**NOTICE OF DECISION TO CONSENT TO CHANGE TO PROPOSAL DURING
ASSESSMENT**

Mesa A Hub Revised Proposal – Assessment No. 2107

STATEMENT OF REASONS

Proposal: Mesa A Hub Revised Proposal

Figure 1: Development Envelopes and conceptual footprints for the referred proposal and the changed proposal

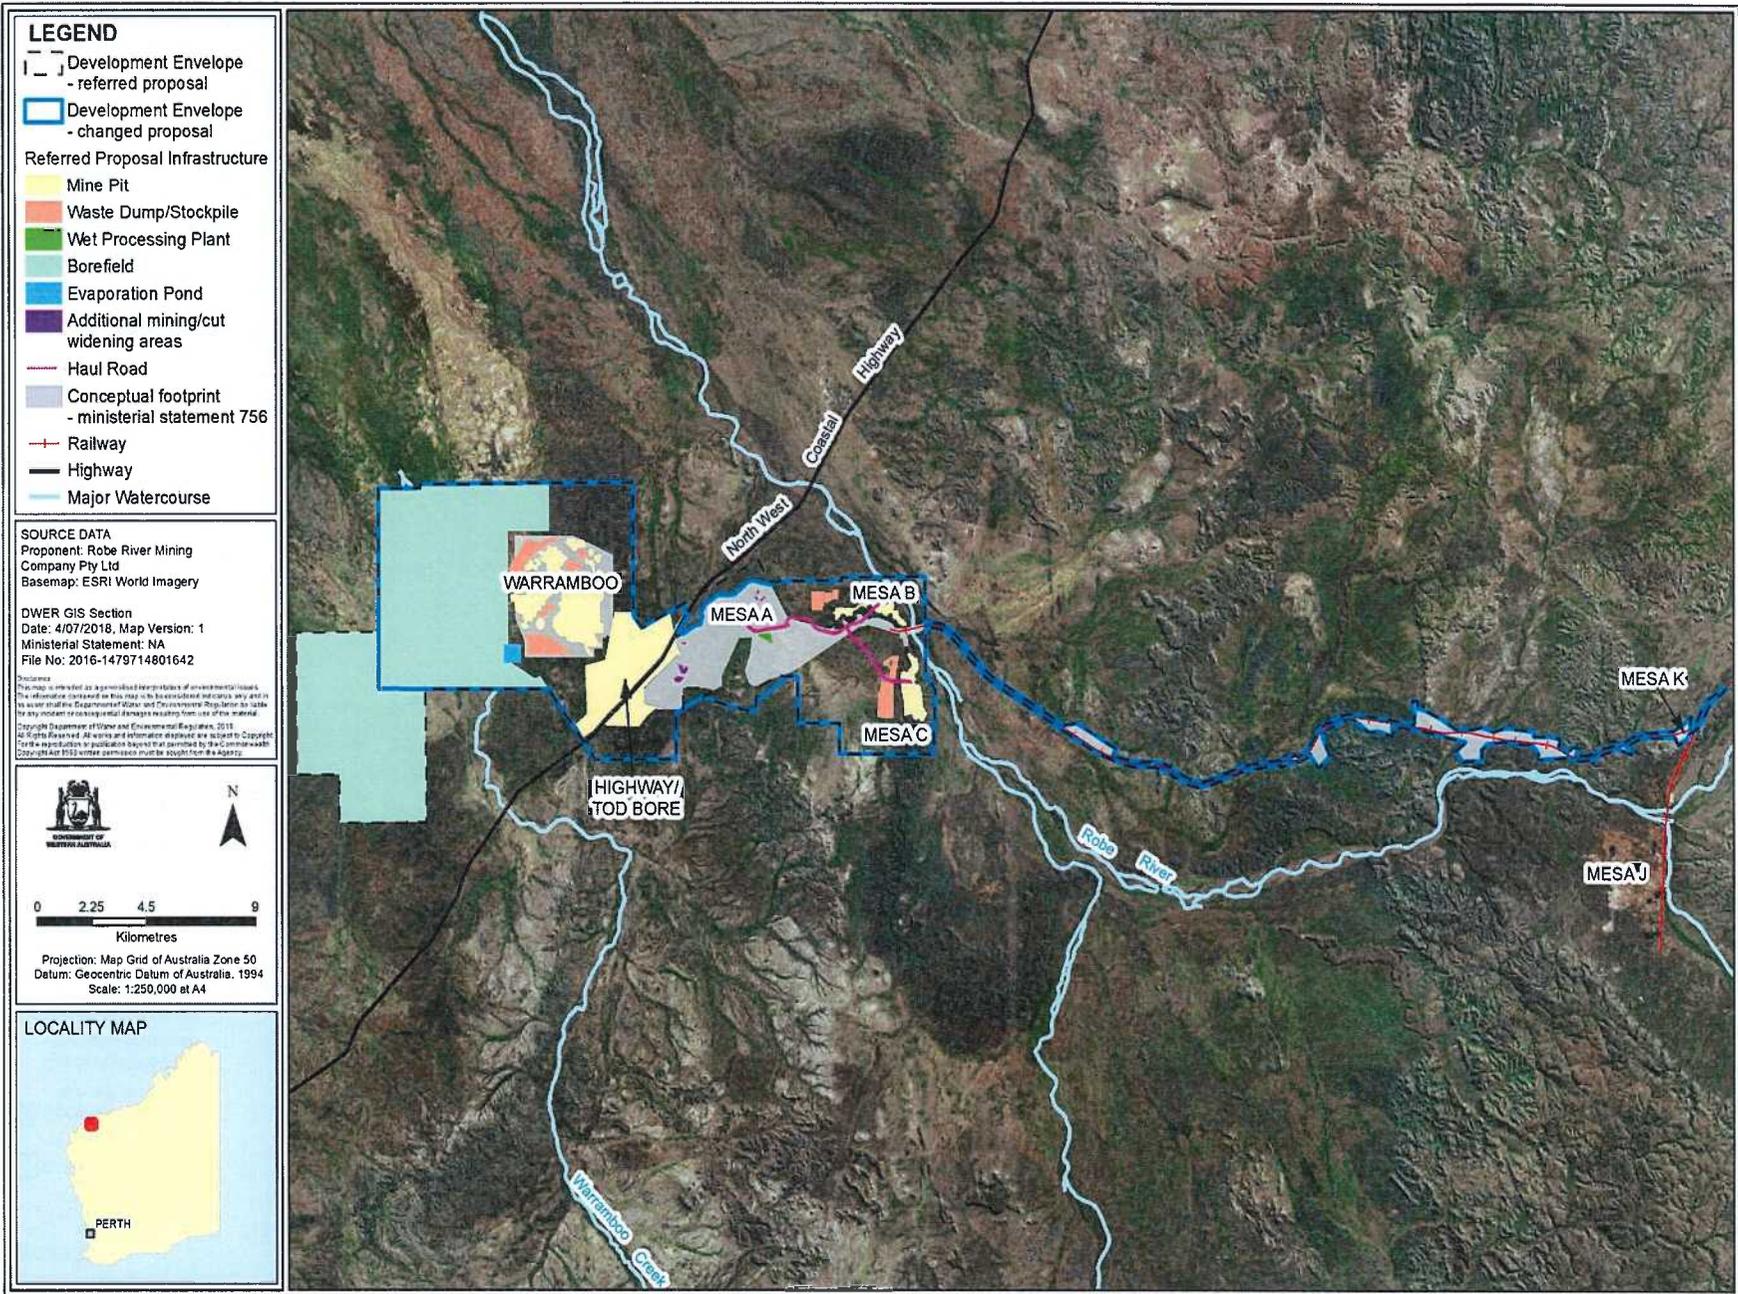
- Reduction in the size of the Development Envelope from 20,184 ha to 16,834 ha (i.e. a reduction of 3,350 ha) [Refer to Figure 1].
- Increase in native vegetation clearing from 2,500 hectares (ha) to 3,000 ha (i.e. an increase of 500 ha) [Refer to Figure 2].
- Increase in peak annual groundwater abstraction rate from 11 gigalitres per year (GL/yr) to 15 GL/yr for dewatering at Warramboos and water supply from the borefield at Warramboos (i.e. an increase of 4 GL/yr).
- In-pit disposal of effluent from the reverse osmosis plant at Warramboos instead of disposal to an evaporation pond.

The area of vegetation that will be cleared will increase by 500 hectares (ha) from 2,500 hectares (ha) to 3,000 ha (i.e. a 20% increase). However, the size of the Development Envelope will decrease by 3,350 ha from 20,184 ha to 16,834 ha (i.e. a decrease of approximately 16.6%) [Figures 1 & 2]. These changes are not considered to be significant as:

Figure 2: Additional areas of vegetation to be cleared for the changed proposal

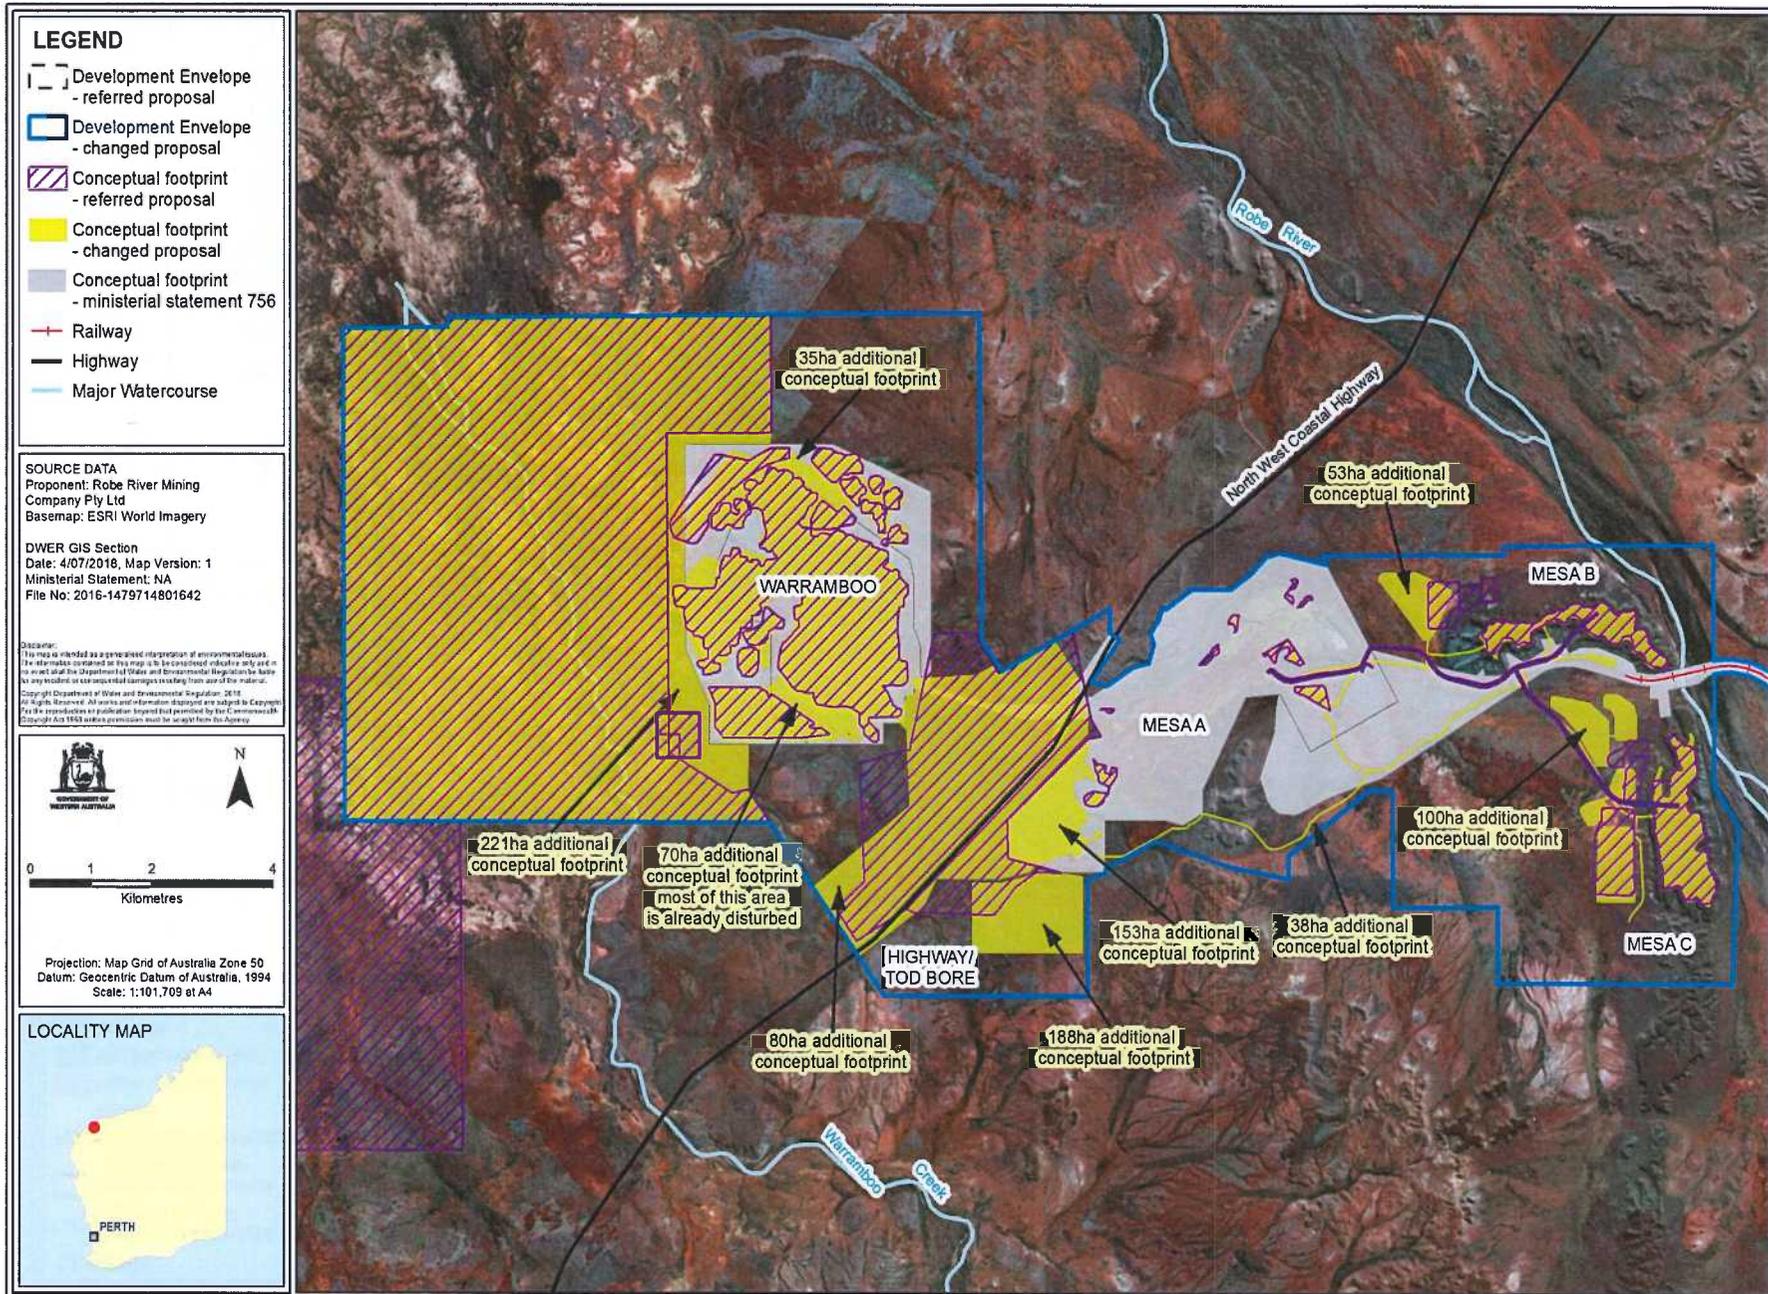
The area of native vegetation that will be cleared will increase by 500 ha (i.e. 20%). However, none of the vegetation units that will be subject to additional clearing are considered to be of high local or regional significance and no Priority flora species will be impacted.
